Proposal for the 10 Series of Amendments to UN Regulation No. 16 (Safety-belts)

Submitted by the expert from The Netherlands *

I. Proposal

- 2-1. Arrangements of the safety-belt approval marks (see paragraph 5.32.5. of this Regulation)

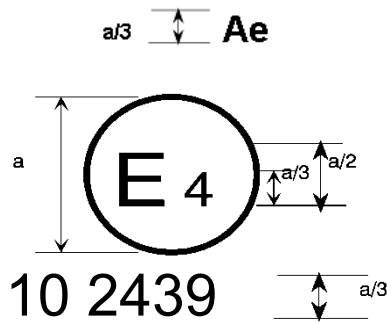
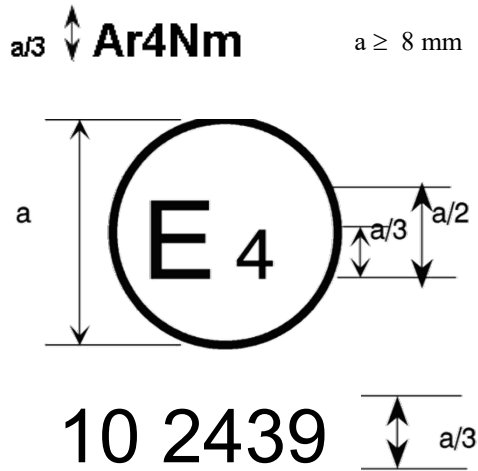
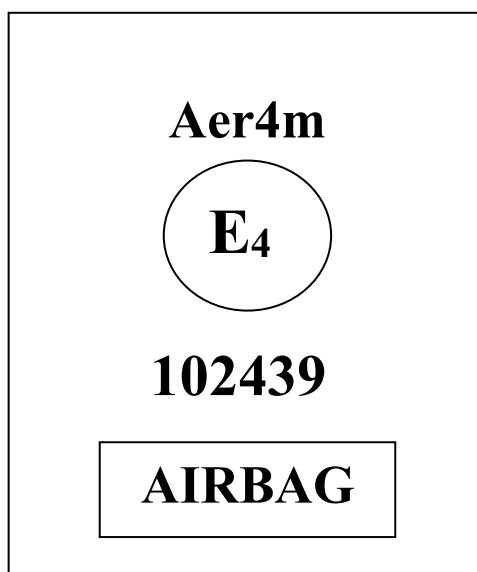
The belt bearing the above approval mark is a three-point belt (“A”), fitted with an energy absorber (“e”) and approved in the Netherlands (E 4) under the number ~~09~~102439, this Regulation already incorporating the ~~06, 07, 08 or 09~~ 10 series of amendments at the time of approval.

The belt bearing the above approval mark is a lap belt (“B”), fitted with a retractor, type 4, with multiple sensitivity (m) and approved in the Netherlands (E 4) under the number ~~09~~102489, this Regulation already incorporating the ~~06, 07, 08 or 09~~ 10 series of amendments at the time of approval.

The belt bearing the above approval mark is a special type belt (“S”), fitted with an energy absorber (“e”) and approved in the Netherlands (E 4) under the number ~~09~~1022439, this Regulation already incorporating the ~~06, 07, 08 or 09~~ 10 series of amendments at the time of approval.

The belt bearing the above approval mark is part of a restraint system (“Z”), it is a special type belt (“S”) fitted with an energy absorber (“e”). It has been approved in the Netherlands (E 4) under the number ~~09~~1024391, this Regulation already incorporating the ~~06, 07, 08 or 09~~ 10 series of amendments at the time of approval.

The belt bearing this type approval mark is a three-point belt (“A”) with a multiple-sensitivity (“m”) type 4N (“r4N”) retractor, in respect of which type approval was granted in the Netherlands (“E 4”) under number ~~09~~102439, this Regulation already incorporating the ~~06, 07, 08 or 09~~ 10 series of amendments at the time of approval. This belt shall not be fitted to vehicles of category M₁.

The safety-belt bearing this type approval mark is a three-point belt (“A”) fitted with an energy absorber (“e”), approved as meeting the specific requirements of paragraph 6.4.1.3.3. or 6.4.1.3.4. of this Regulation, and with a multiple-sensitivity (“m”) type 4 (“r4”) retractor, in respect of which type approval was granted in the Netherlands (“E 4”) under the approval number ~~09~~102439. The first two digits indicate that the Regulation already incorporated the ~~06, 07, 08 or 09~~ 10 series of amendments at the time of the approval. This safety-belt has to be fitted to a vehicle equipped with an airbag in the given seating position.
